# Value Engineering Study

Final Report

## Hal Rogers Parkway KY 30 to KY 192 (MP 1.089 to MP 3.877) Laurel County Item No. 11-365.00

May 25, 2022

VALUE ENGINEERING (VE) PROPOSAL NO. 06

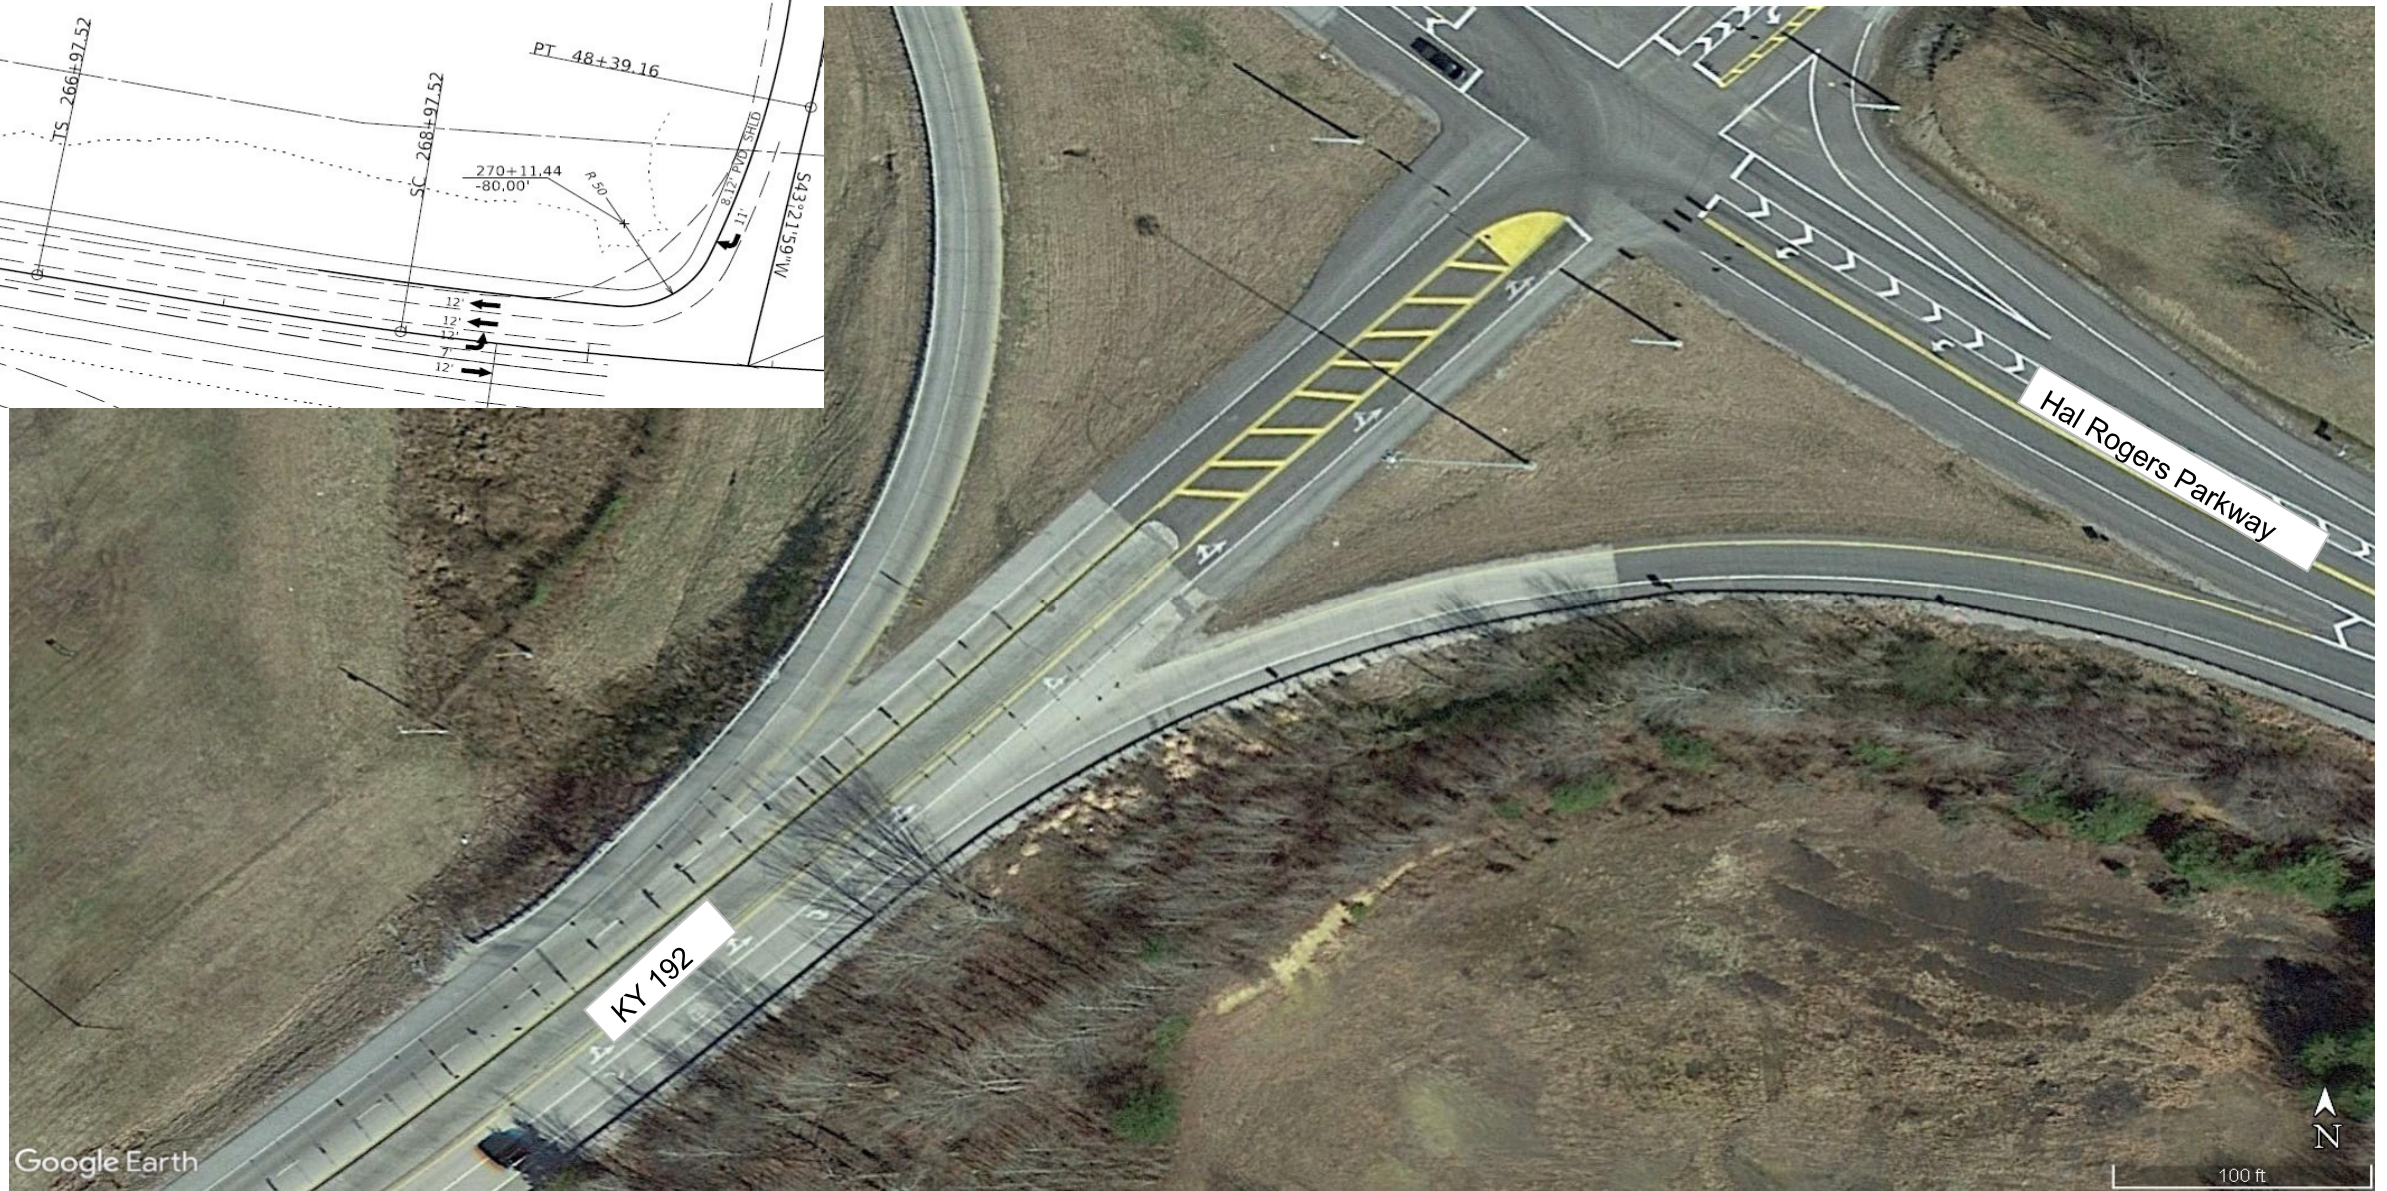
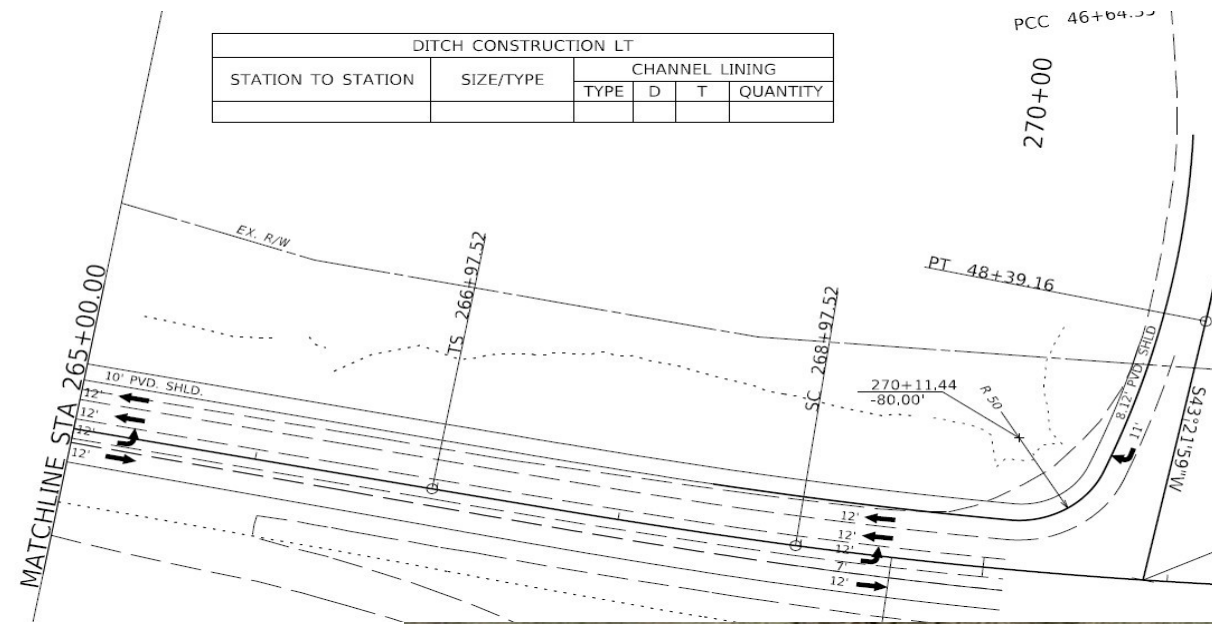
<b>TITLE</b>	Add a dual-left from northbound KY 192 onto Hal Rogers Parkway		
<b>FUNCTION</b>	<b>Increase Capacity (Improve traffic flow, reduce delay)</b>		
<b>VALUE PROPOSAL SYNOPSIS:</b>			
The northbound left turning movement from KY 192 onto the Hal Rogers Parkway experiences significant queuing, delays, and poor level of service due to the high volume demand and limited green time. A second, designated, left turn lane should be constructed to provide more capacity for this movement.			
 <b>Reliability</b>	Maintained	 <b>Functionality</b>	Improved
 <b>O&amp;M</b>	Maintained	 <b>Schedule Impact</b>	Degraded
			<b>\$ Initial Cost Avoidance (Add)</b>
			<b>(\$100,000)</b>
<b>BASELINE CONCEPT:</b>			
There would be no change to the baseline concept. This is in addition to the baseline concept.			
<b>VE PROPOSAL DESCRIPTION:</b>			
Construct a designated left turn lane in the northbound left turning movement at the intersection of Hal Rogers Parkway and KY 192.

<b>TITLE</b>	Add a dual-left from northbound KY 192 onto Hal Rogers Parkway
<b>DISCUSSION &amp; JUSTIFICATION:</b>	
<p>A known issue at the intersection of Hal Rogers Parkway and KY 192 is the northbound left turning movement from KY 192 onto Hal Rogers Parkway westbound. This signal currently operates with split phasing between the northbound and southbound traffic. The baseline design showed an additional lane being constructed in the Hal Rogers Parkway westbound direction beginning at KY 192. The baseline showed the southbound right turning movement free flowing onto the parkway and utilizing the added through lane. Due to the low volume in the southbound direction, it is recommended that an additional left turn lane be constructed in the northbound approach to provide a dual-left onto Hal Rogers Parkway. The information phase for this project made no mention of any issues in the southbound movements; therefore, having the southbound movements continuing to operate as split phased movements with the northbound traffic should have no negative effect on the southbound movement or require an existing issue to remain.</p> <p>The proposed sketch and cost estimate assume a turn lane with 300 feet of storage be taken from the raised median along KY 192. The median would be removed and roadway excavation performed to match the depth of the proposed pavement along mainline. A new header curb would be constructed for where the island was reduced in size and a new lane poured to match the mainline pavement design. The stop bar for the added turn lane should be placed such that left turning movements from Hal Rogers Parkway onto KY 192 will be able to avoid contact with vehicles queued in the added turn lane.</p> <p>Based on the highway capacity analysis performed using estimated turning movement volumes, the baseline intersection operates as a level of service (LOS) "F" with an intersection delay of 118.9 seconds. With this proposal, the conditions improve to a LOS "D" with a delay of 39.4 seconds. The queue for the northbound lefts reduces from 1470 ft in a single lane to 615 feet in two lanes.</p>

TITLE Add a sidewalk on the bridge

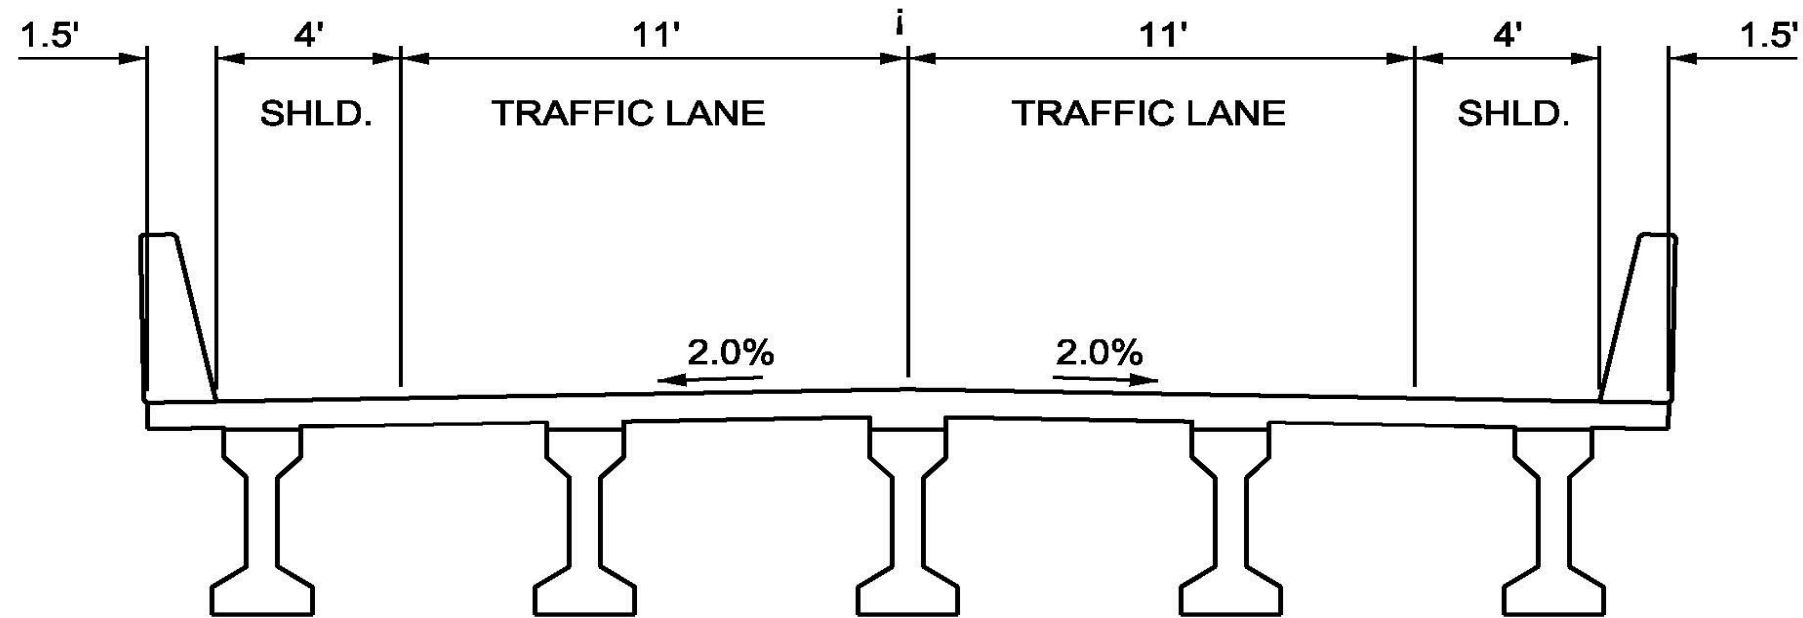
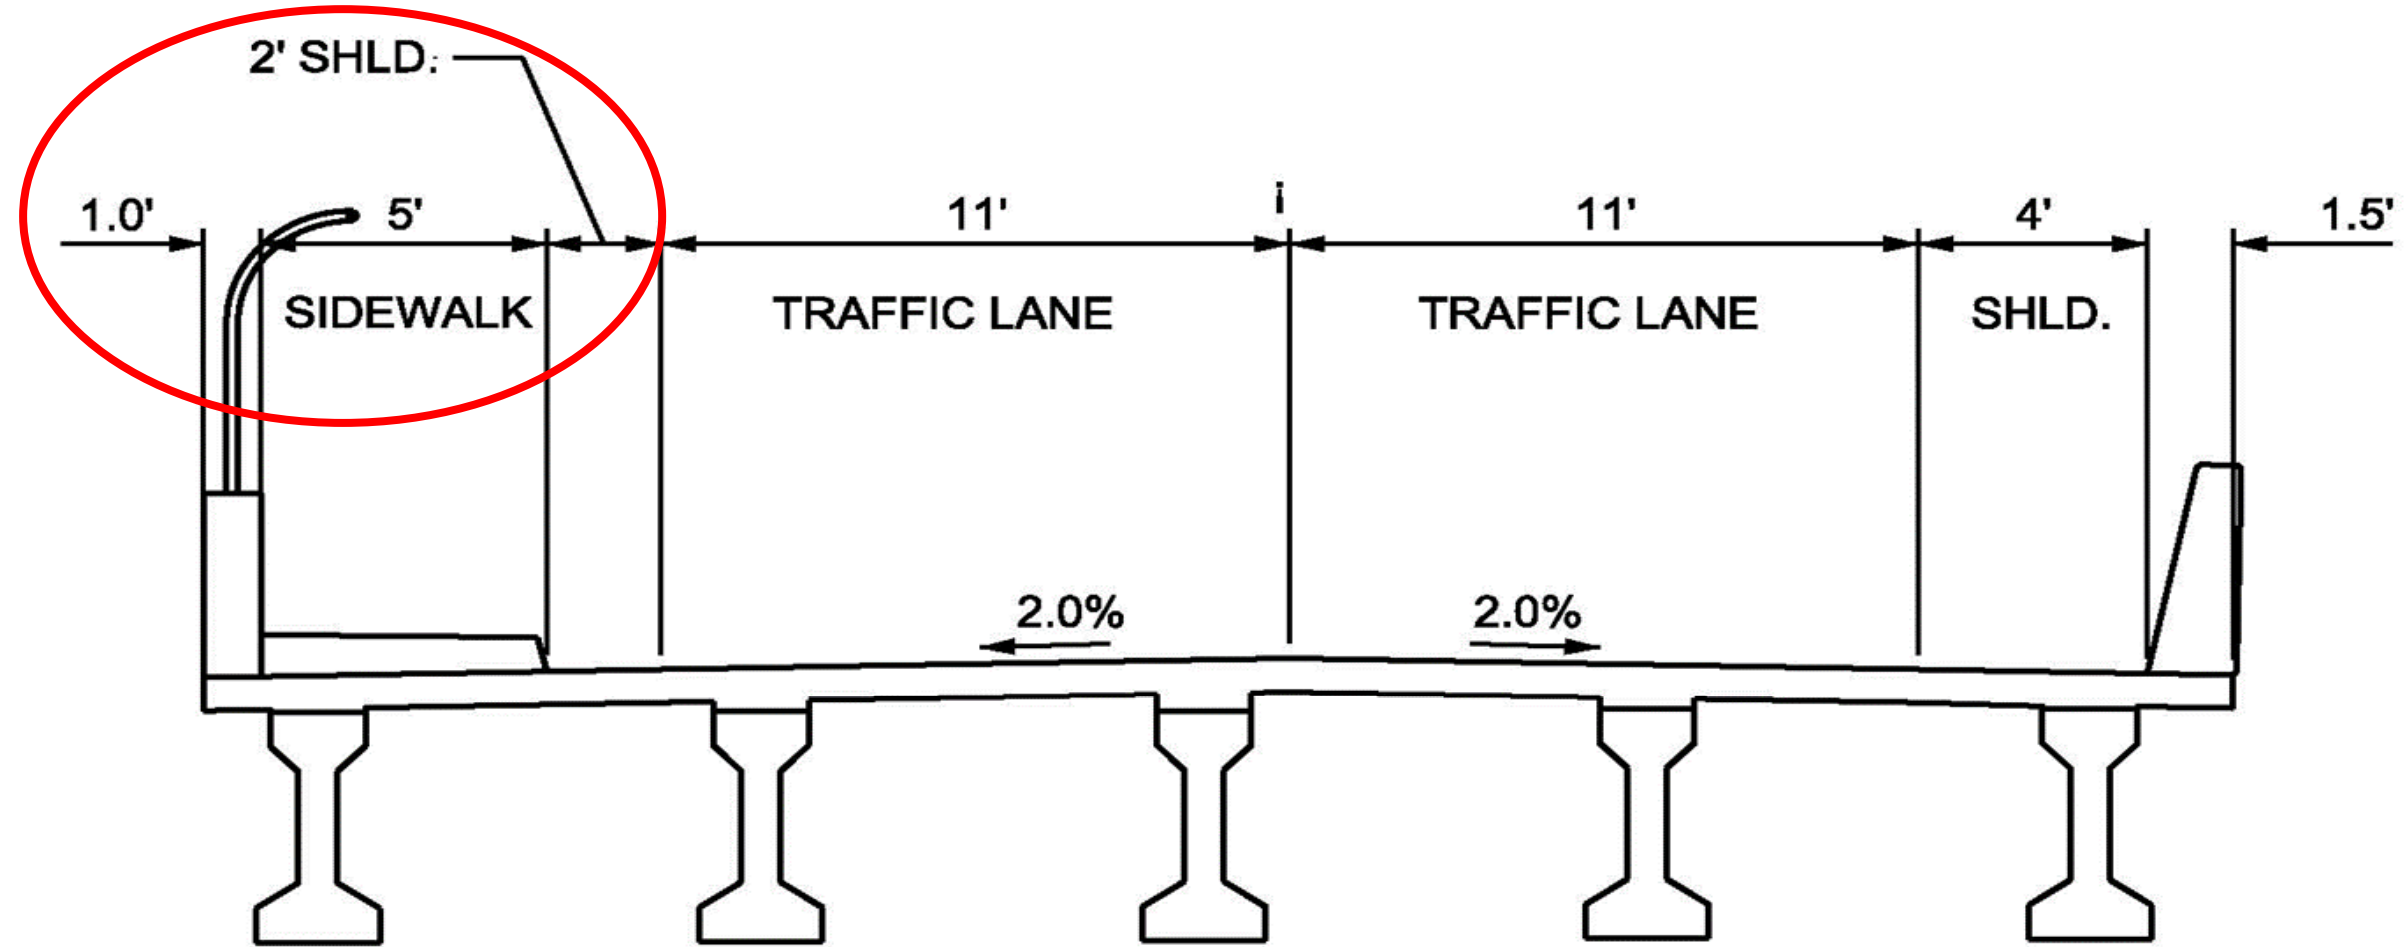
<b>TITLE</b>	Add a sidewalk on the bridge		
<b>FUNCTION</b>	<b>Protect People</b>		
<b>VALUE PROPOSAL SYNOPSIS:</b>			
The baseline requires the existing Slate Lick Bridge to be replaced with a new bridge that has a total width of 33-ft. A 5-ft sidewalk can be added by adding 3-ft (36-ft total width), with minimal additional bridge cost that will significantly increase safety for kids walking to school across this bridge.			
 <b>Reliability</b>	<b>Improved</b>	 <b>Functionality</b>	<b>Improved</b>
 <b>O&amp;M</b>	<b>Maintained</b>	 <b>Schedule Impact</b>	<b>Maintained</b>
			<b>\$ Initial Cost Avoidance (Add)</b>
			<b>(\$113,000)</b>
<b>BASELINE CONCEPT:</b>			
The baseline bridge has two 11-ft lanes with 4-ft shoulders and single sloped barriers			
<b>VE PROPOSAL DESCRIPTION:</b>			
Add a 5-ft sidewalk but decrease the shoulder on the sidewalk side from 4-ft to 2-ft and the 1.5-ft wide single sloped barrier is replaced with a 1-ft wide straight wall with a handrail along the proposed sidewalk.

<b>TITLE</b>	Add a sidewalk on the bridge
<b>DISCUSSION &amp; JUSTIFICATION:</b>	
<p>The baseline is replacing the existing Slate Run Bridge with a new bridge because the existing shoulder piers are too close to allow the proposed 5-lane roadway section with 12-ft shoulders to pass through.</p> <p>With the bridge being replaced, now is the time to add a sidewalk. Even though there are currently no sidewalks along Slate Lick Road, school children walking to school along Slate Lick Road from the south side of Hal Rogers Parkway have no place of safety in case of an errant car while walking across the bridge.</p> <p>Adding a sidewalk will increase the cost of the bridge by about 9% which is a small price to pay for the added safety for children walking or riding their bikes to school. This also allows for a future project to add a sidewalk along Slate Lick Road.</p> <p>The proposal shows the sidewalk to be constructed on the school side so children do not need to cross Slate Lick Road when they arrive at school or leave school in the afternoon. Since the proposal reduces the shoulder on the sidewalk side from 4-ft to 2-ft, it may make sense to reduce the other shoulder to 2-ft as well. If this is done then this proposal widens the proposed baseline bridge by 1-ft which will increase cost minimally.</p>
